Downtown Bicycle Routes Submission

February 2024

Bike Winnipeg welcomes the opportunity to provide feedback on the conceptual designs for the St Mary-York and Notre Dame-Cumberland bicycle routes.

2 St. Mary Avenue at Memorial Boulevard

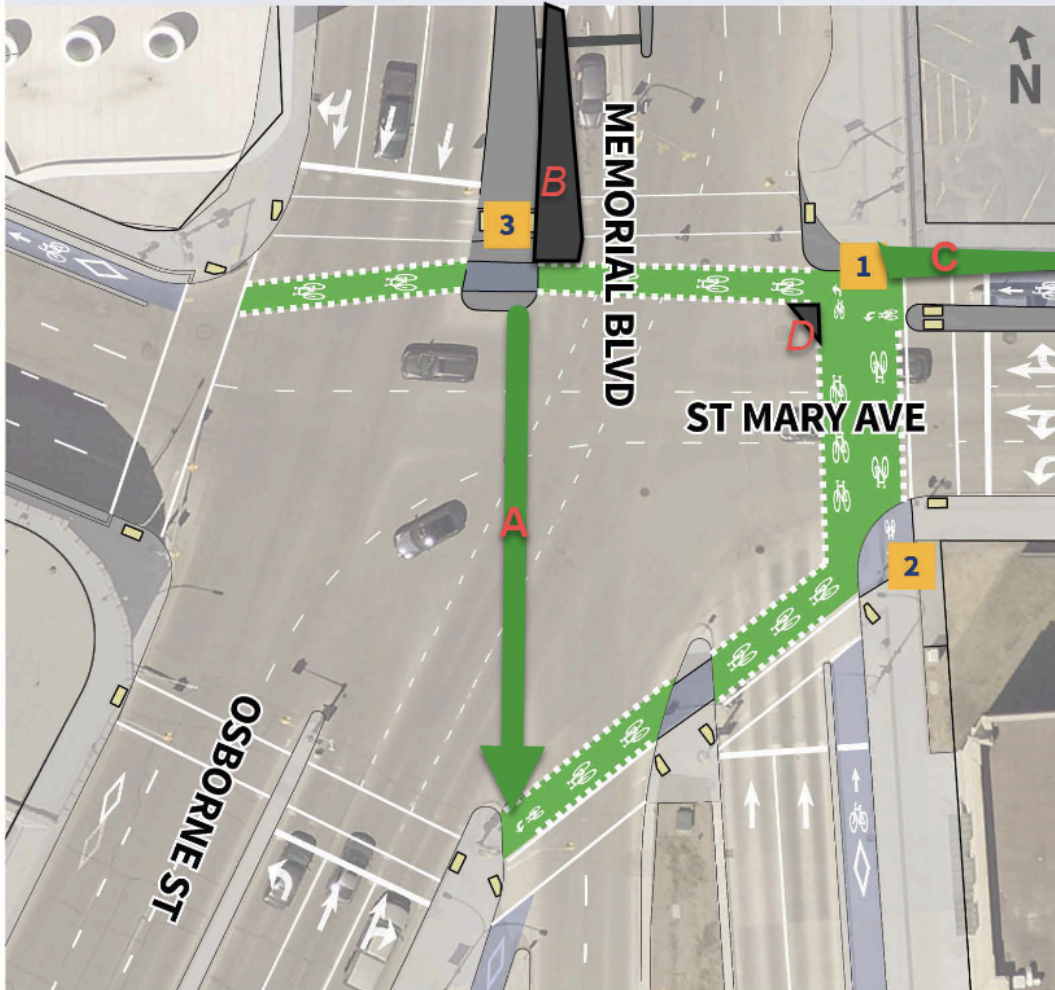
We would like to see a second connection between St. Mary and Memorial, preferably utilizing a bike box protected by the widened median shown as item 3 below. The presence of this second route (shown as A below) to Memorial would ensure that someone cycling westbound on St. Mary trying to make the left onto Memorial could complete their turn with less average delay than via the option presented, which requires the person on bike to cross St. Mary and both legs of Memorial before continuing south. The second option presented here allows someone riding west on a green light to cross Memorial before waiting for the green phase allowing southbound Memorial to cross St. Mary. There does not seem to be any conflict between this route and any allowed movements of traffic through the intersection on the phase allowing southbound traffic along Memorial.

Additional space for a bike box could be provided by reducing the number of lanes for Memorial through traffic from two lanes to one lane (shown as B below). If the extra stacking lane for the connection to Memorial cannot be removed, a bike box in the right most stacking lane needs to be added to provide stacking space for people on bikes to make the two-stage left turn from St. Mary to Memorial. Either way, the bike box enabling this second two-stage turn movement from St. Mary to Memorial should be located in front of the crosswalk,

Whatever decision is made with respect to the above, the bike box shown as item 1 below needs to be widened to prevent people stacking up to turn left blocking the route of those who will continue their route west across Memorial and Osborne St. Stacking space for this turn needs to be added in the leadup to the crossing, This could be done by shifting the through bike lane into the boulevard (shown as C below). Alternatively, space may be available within the proposed bicycle lane and roadway to add the stacking lane without need to widen into the boulevard. Regardless, the stacking space provided for people making the left turn onto Memorial needs to be placed in a space that will feel protected from the traffic on St. Mary. The preferred option of having two one way cycle tracks along both St. Mary and York may make this easier than the two-way option along York.

A corner island should be added to the intersection (Item D below) to reduce right hook risks. With three lanes to turn into, this should not be a problem.

A - Southbound bike lane to decrease average wait times for people on bikes
B - Widen median to provide appropriate amount of cyclist refuge
C - Add stacking lane to facilitate left turns for people on bikes
D - Add corner island to reduce right hood risk

Carlton @ Notre Dame

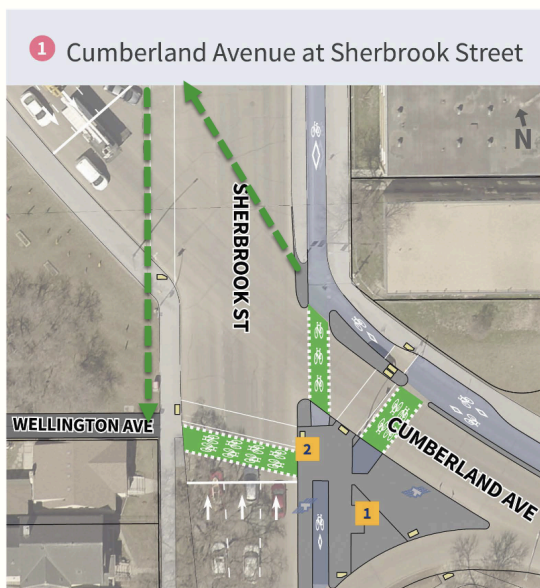
With three lanes to turn into on Notre Dame, why can't we have a fully protected intersection here that would provide a protected refuge for those people on bikes making the left turn off westbound Notre Dame onto southbound Carlton?

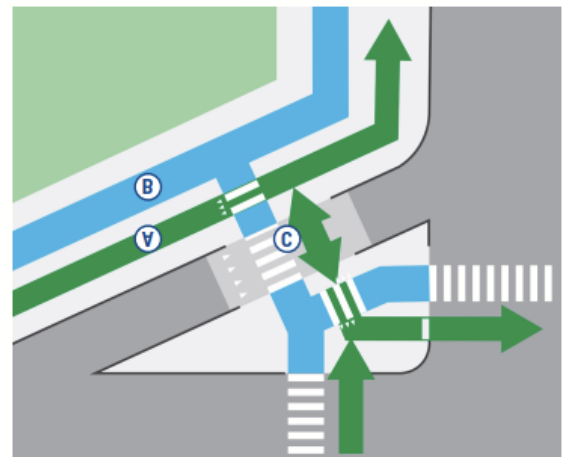
Extending the westbound bikeway across Sherbrook would reduce average wait times by allowing people biking west to continue across Sherbrook on a green cycle phase rather than having to wait through separate phases to cross Cumberland and then Sherbrook. To avoid traffic turning left off of Cumberland onto Sherbrook, a smart channel protracted corner could be installed.

An (inverted) example of a Smart Channel Protected Corner from the Ottawa Protected Intersection Guidelines. Such a design may be of benefit if the westbound cycle track along Cumberland were continued west to Maryland and the Olivia St cut through.

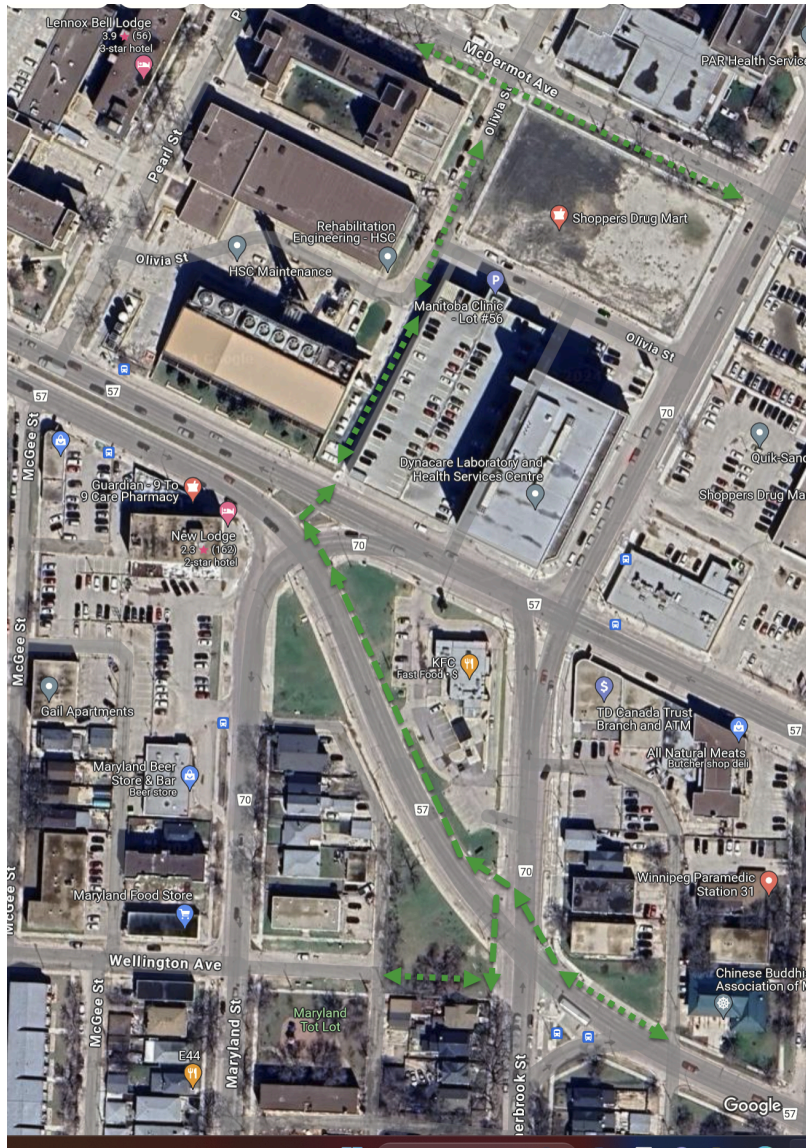
We recommend that the west bound bike lane along Cumberland be extended west across Sherbrook to reduce average wait times connecting between Cumberland and Wellington or Olivia St.

If the westbound cycle track was extended all the way to the signal at Mayland, people on bikes would be able to access the Olivia-Mayland cut-through and gain direct access to the Health Science Centre Complex without having to negotiate travel on and across Sherbrook. There would be no conflict with traffic coming off Notre Dame onto Cumberland, so phasing for this crossing would be simple. The avoidance of stops at Notre Dame and McDermot would provide a sizable time savings.

Continuing the westbound bike lane along Cumberland up to the intersection with Maryland and the Olivia St cut through would improve connections to the Health Sciences Centre Complex.

Cumberland @ Hargrave

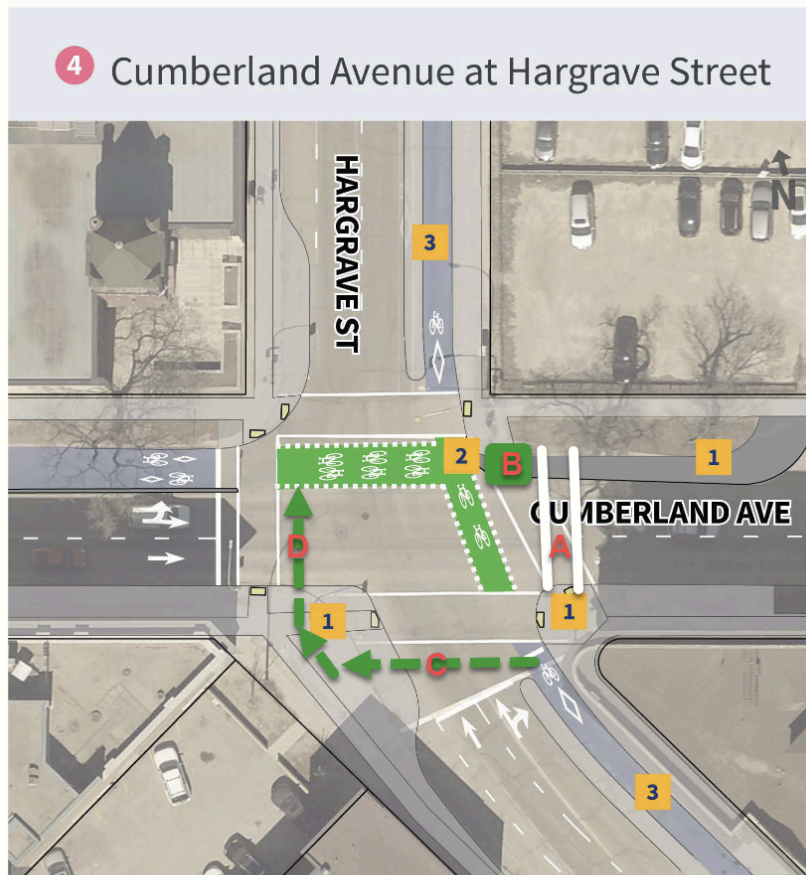
If the sidewalk were pushed back to cross Cumberland at a right angle (see item A below), you could actually provide stacking space (see item B) to the right of the northbound Hargrave protected bike lane that would provide a protected stacking space for people making the left turn off Hargrave onto westbound Cumberland.

There also seems to be ample space in the southwest corner of the intersection to allow a protected crossing of Hargrave south of Cumberland (item C above), which could be paired with a short contraflow bike lane on the west side of Hargrave (item D above) to allow for a crossing of Cumberland on the Hargrave phase of the traffic cycle.
